December 8, 2017

NOTICE OF ADDENDUM
ADDENDUM NO. 1

CONTRACT NO. 8064, PROJECT NO. 11225
MADISON METRO BUS GARAGE – ROOF REPLACEMENT

AD100

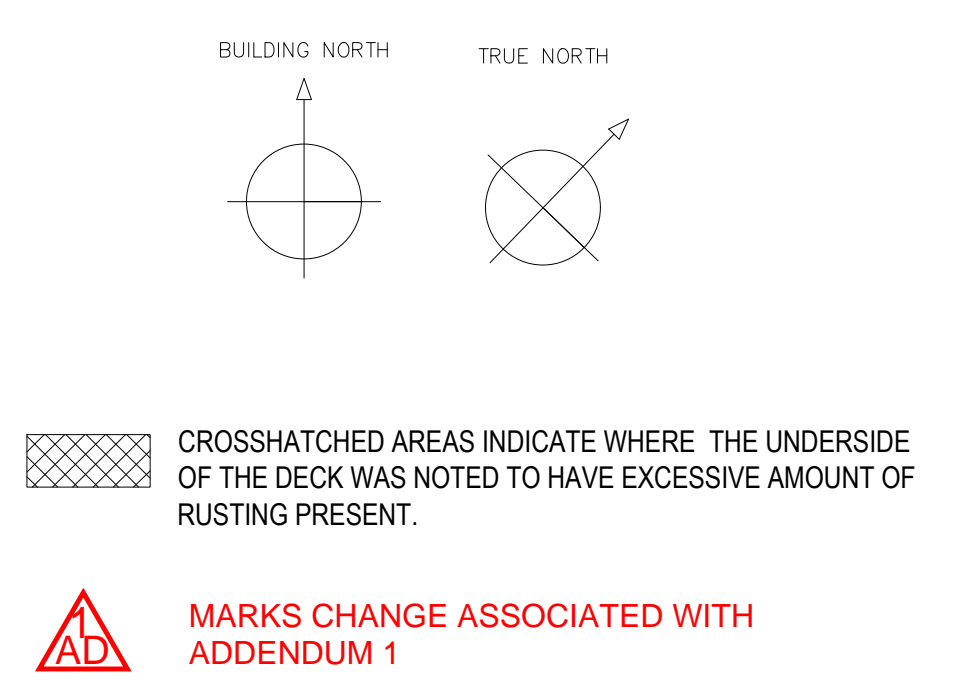
What are the requirements for replacing the wood stairs?

Minor formatting changes, clarification of stair replacement responsibility, see AD-1 markings on sheets: AD100, A100

- WOODEN STAIRS: THE CONTRACTOR SHALL BE RESPONSIBLE FOR REMOVING ALL WOODEN STAIRS & MAKE NECESSARY REPAIRS OR ADJUSTMENTS WHEN REINSTALLED. IF ANY STAIRS CAN NOT BE REUSED THE CONTRACTOR SHALL REPLACE WITH NEW.

- *This should be eliminated from the scope. Metro will replace the stairs (per Jim Fink).*

Roof Plan	
CONTRACT #	8064
MUNIS #	11226
DRWN BY:	PBS
DATE:	10/30/17
REV:	11/10/17
AD-1	12/8/17
SHEET	
A100

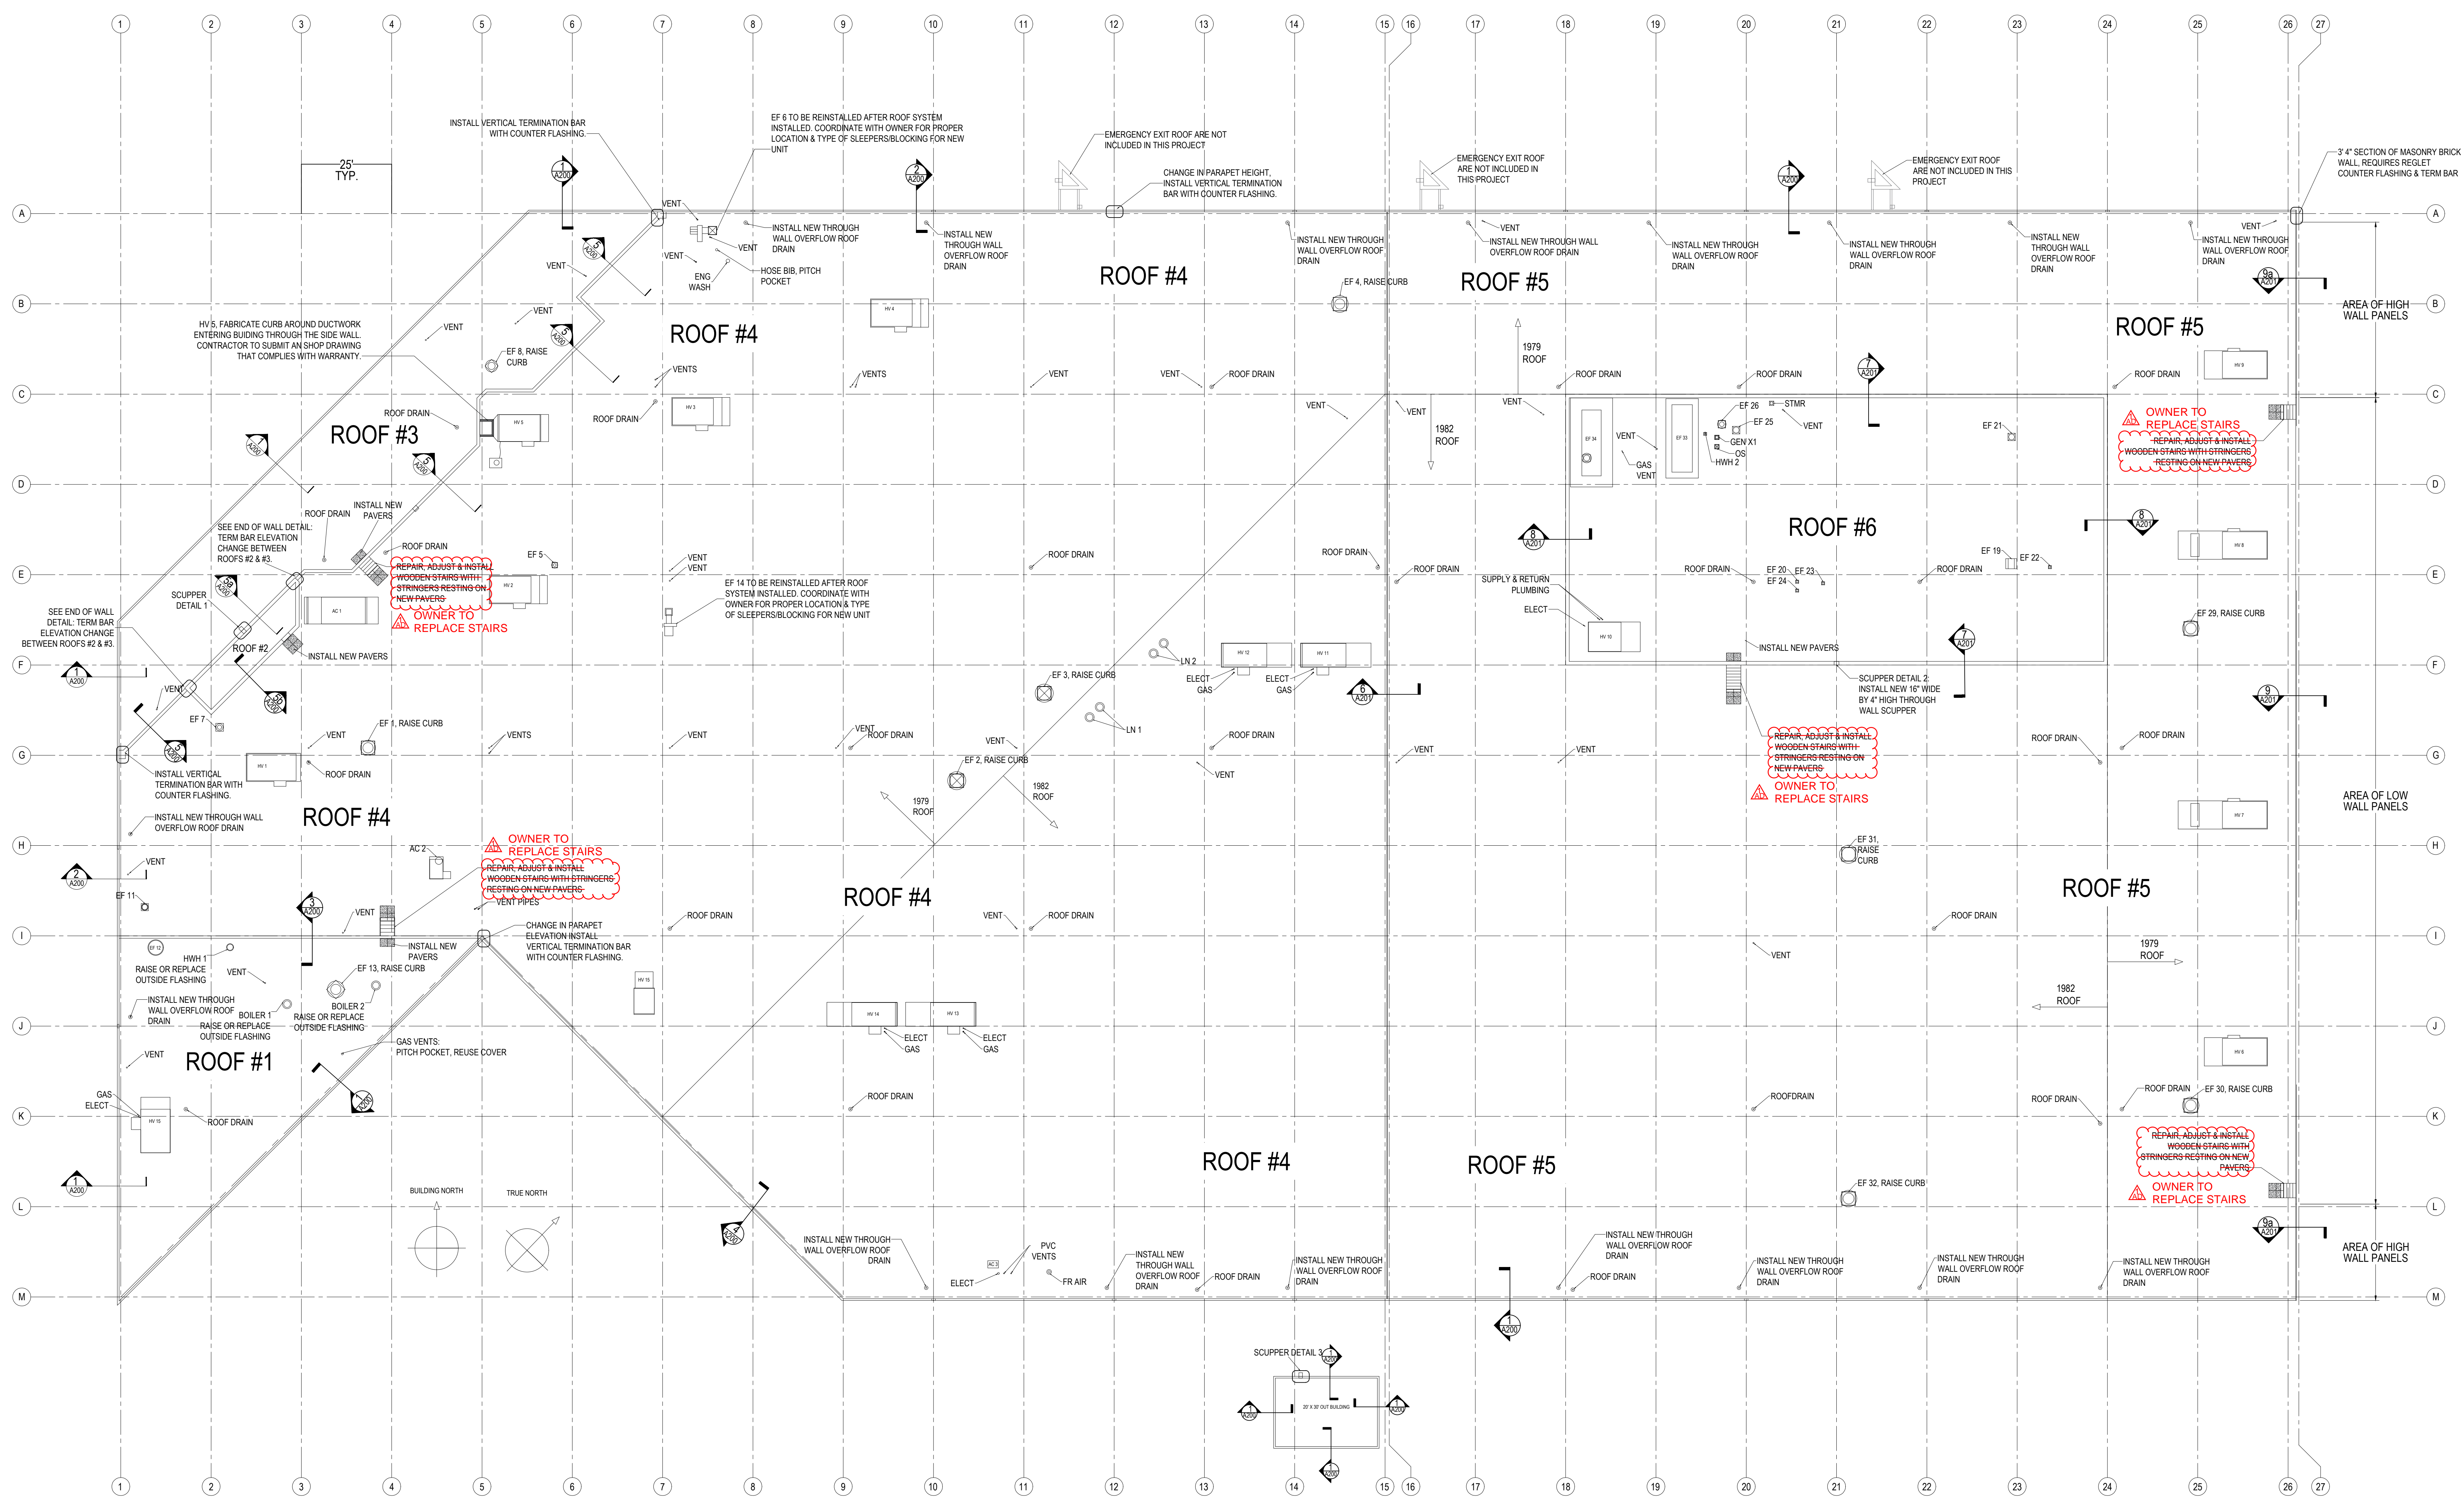
MARKS CHANGE ASSOCIATED WITH ADDENDUM 1

CONTRACTOR STAGING AREA MAP

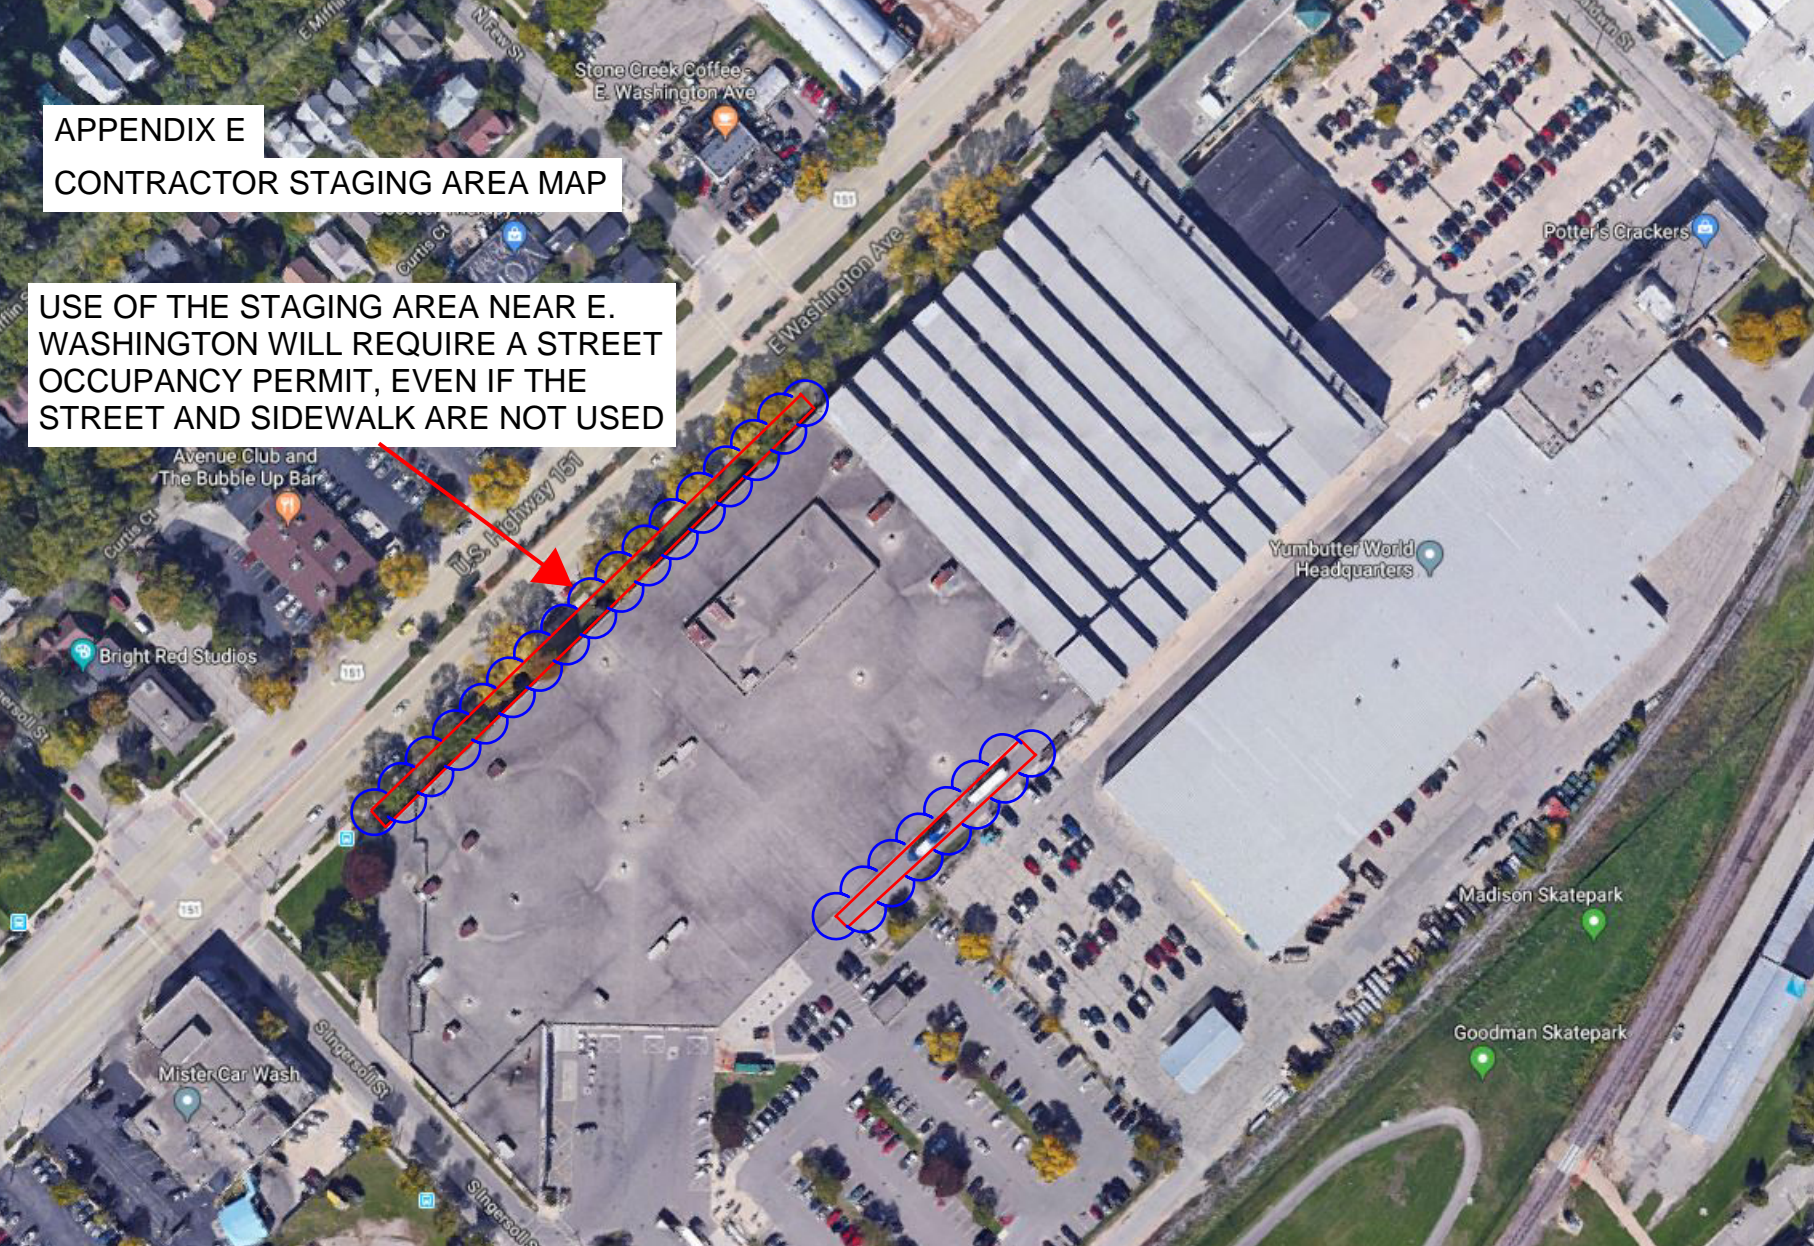
Where can we stage equipment and supplies?

Can East Washington Ave side of the building be used as a staging area?

- *Equipment can be staged along the east Washington ave. side of the building (see next question), and in select areas on the parking lot side of the building. These areas are indicated in Appendix E*

- *Yes, the Metro grounds along E Washington can be used as a staging area. The sidewalk and parking lane may also potentially be used as a staging area. Use of any/all of these areas will require a street occupancy permit. Permit information can be found here:
<https://www.cityofmadison.com/development-services-center/land-development/public-right-of-way/street-occupancy>*

USE OF THE STAGING AREA NEAR E. WASHINGTON WILL REQUIRE A STREET OCCUPANCY PERMIT, EVEN IF THE STREET AND SIDEWALK ARE NOT USED
